ADMINISTRATIVE AMENDMENT (FPA) ADD2014-00213

**ADMINISTRATIVE AMENDMENT
LEE COUNTY, FLORIDA**

FINAL PLAN APPROVAL
UNIVERSITY VILLAGE PHASE I
AT MIROMAR LAKES

Case: ADD2014-00213

① LAKE CROSS SECTION WITH TURF REINFORCEMENT MAT

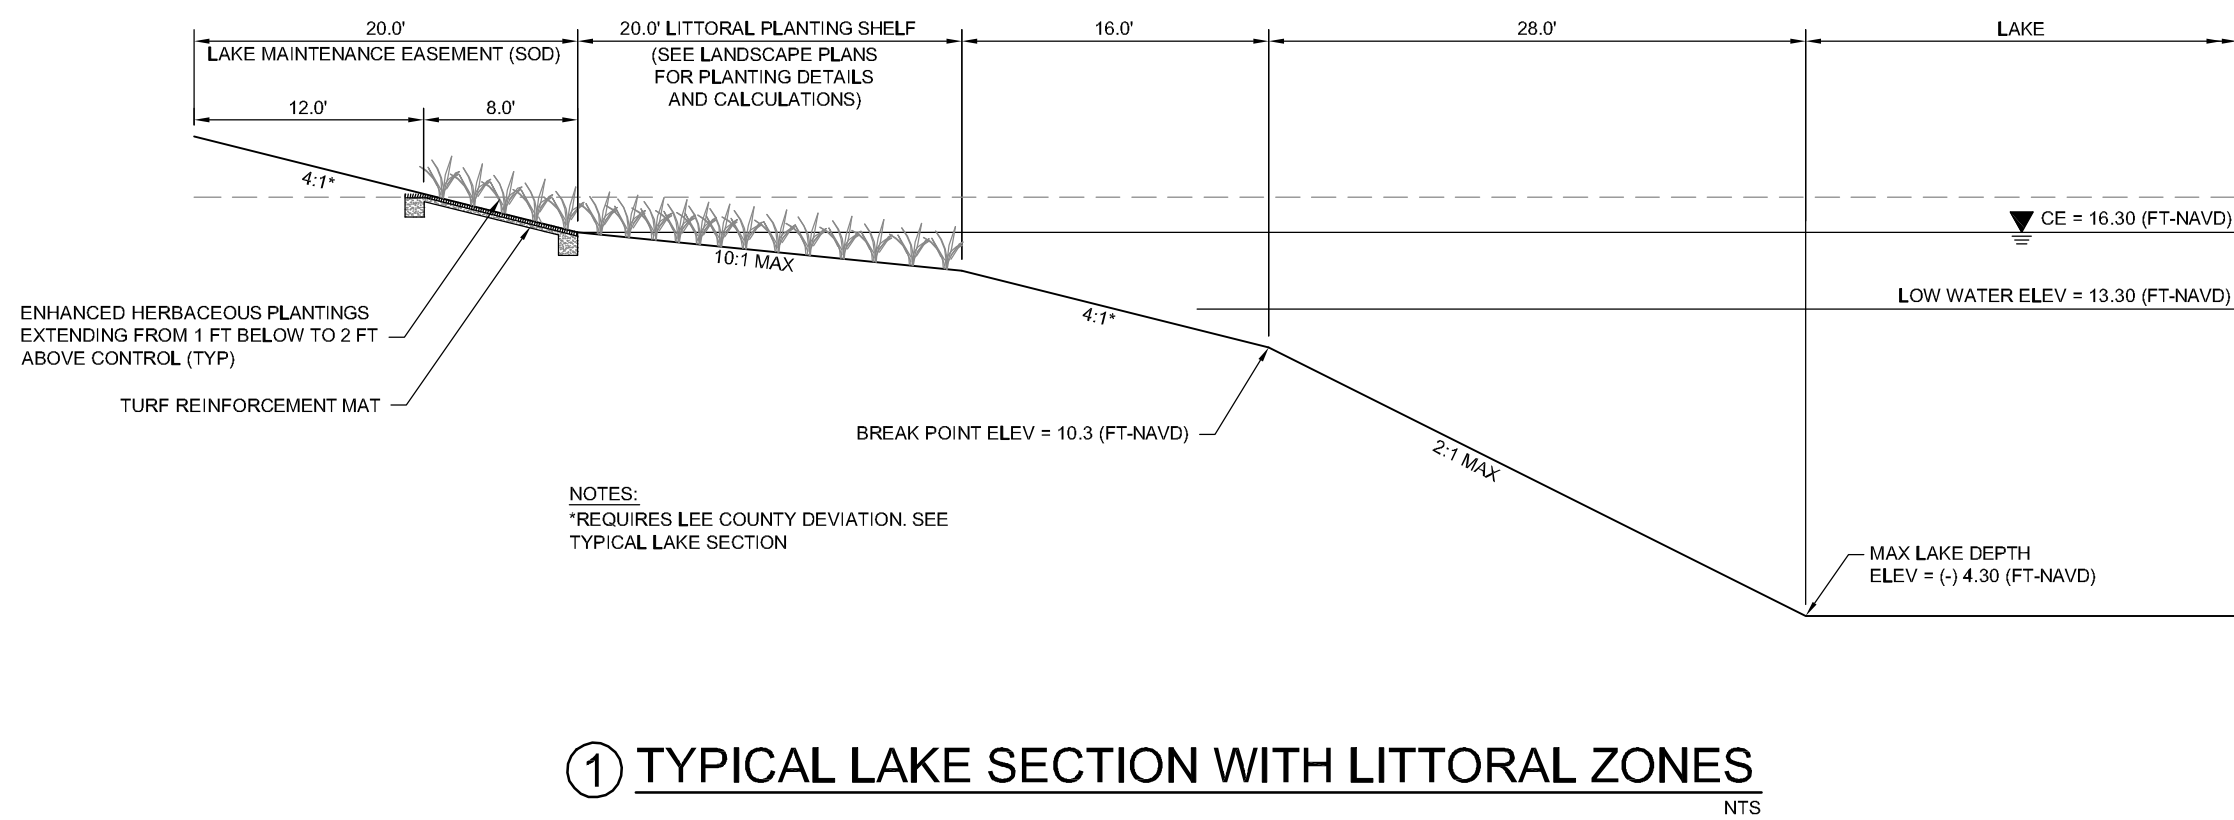
Deviation #1 requests to deviate from LDC Section 10-329(d)(4) requiring lake banks to be sloped at 6:1 ratio from the top of bank to a water depth of two feet below dry season water table: to allow for a minimum ratio of 4:1 where turf reinforcement mat is proposed.

The FPA depicts turf reinforcement mats proposed along the entire shoreline of the two lakes except where bulkhead is proposed for a total of 4,020± linear feet (4,440-420). The lake bank cross sections indicate that the enhanced littorals, used in combination with appropriate turf reinforcement mat as required by LDC Section 329(d)(4) and install a minimum 6,500 littorals at a minimum 2-feet below control to 2-feet above control for a total of 6,500 enhanced littorals. ES staff does not object to the deviation requests and defers to Development Services staff for final recommendation.

Regarding requested deviation no. 1 (from the required 6:1 bank sideslope to allow a 4:1 sideslope): Staff supports this deviation with the condition that turf reinforcement be provided to mitigate bank erosion and the bank sideslopes are maintained by the appropriate entity in perpetuity.

Condition #1 – Development order landscape plans must depict a total of 6,500 enhanced littorals provided in combination with the turf reinforcement mats. These enhanced littoral plantings are required in addition to the code minimum littoral plantings and the increased littorals to offset the bulkhead shoreline.

Condition #2 – Turf reinforcement be provided to mitigate bank erosion and the bank sideslopes are maintained by the appropriate entity in perpetuity.
7. **Deviation #2 is approved.**

Development order landscape plans must depict a total of 6,500 enhanced littorals provided in combination with the turf reinforcement mats. These enhanced littoral plantings are required in addition to the code minimum littoral plantings and the increased littorals to offset the bulkhead shoreline.
